Proposal #36: 7995-02-59, WISC 2024082
C Eau Claire, Fairfax Street
S Hastings Way to Spooner Avenue
Local Street
Eau Claire County

This is Addendum No. 02, which provides for the following:

ADDENDUM NO. 02

Addendum No. 02
 ID 7995-02-59
 Revised Sheet 16
 December 7, 2023

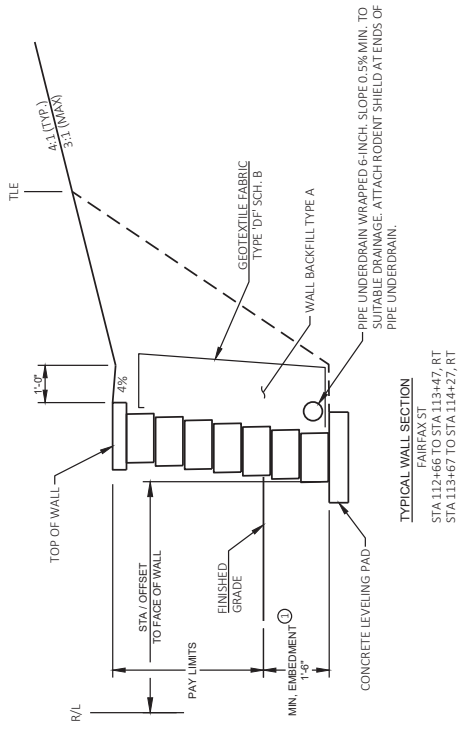
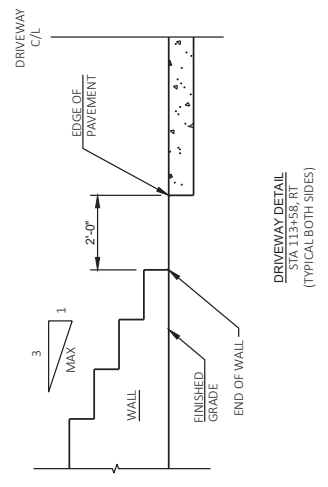
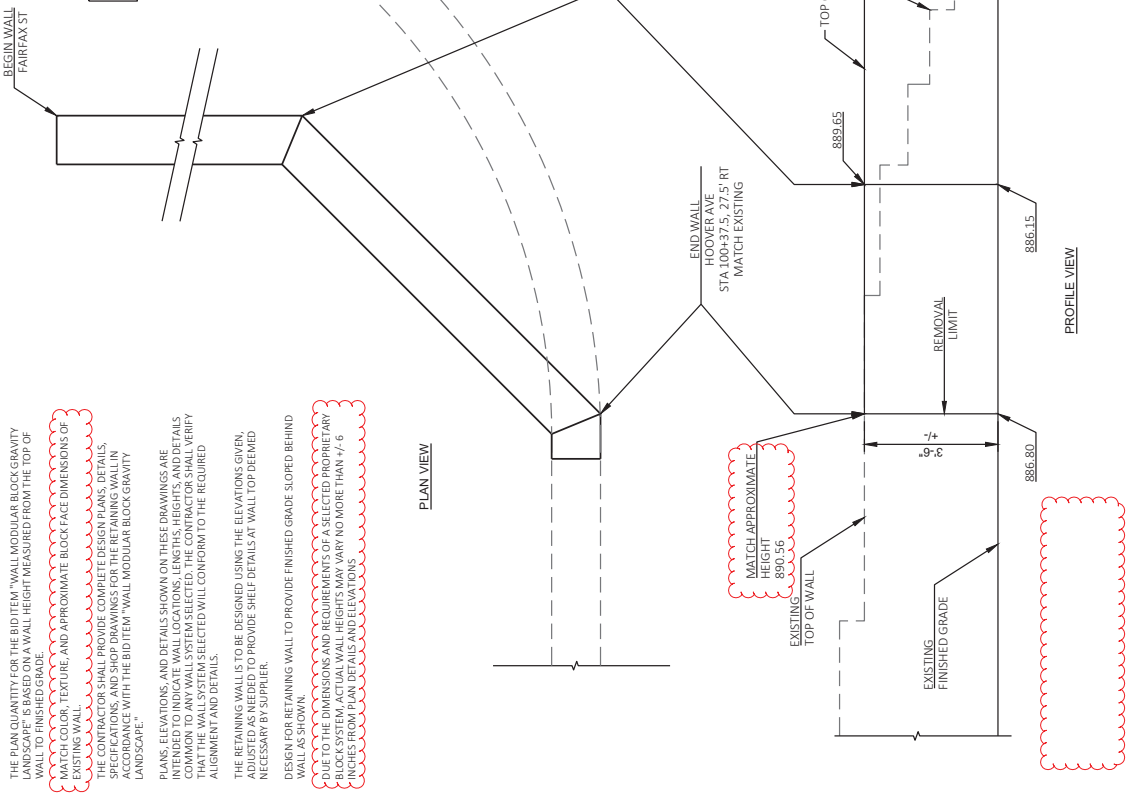
Revised Plan Sheets	
Plan Sheet	Plan Sheet Title (brief description of changes to sheet)
16	Construction Details (Add note and revise information)
17	Construction Details (Revise information)

- DESIGN FOR RETAINING WALL TO PROVIDE FINISHED GRADE SLOPED BEHIND WALL AS SHOWN.
- NOTE: DUE TO THE DIMENSIONS AND REQUIREMENTS OF A SELECTED PROPRIETARY WALL SYSTEM, THERE MAY BE VARIATIONS IN WALL HEIGHTS OF UP TO 4 INCHES FROM PLAN DETAILS AND ELEVATIONS.
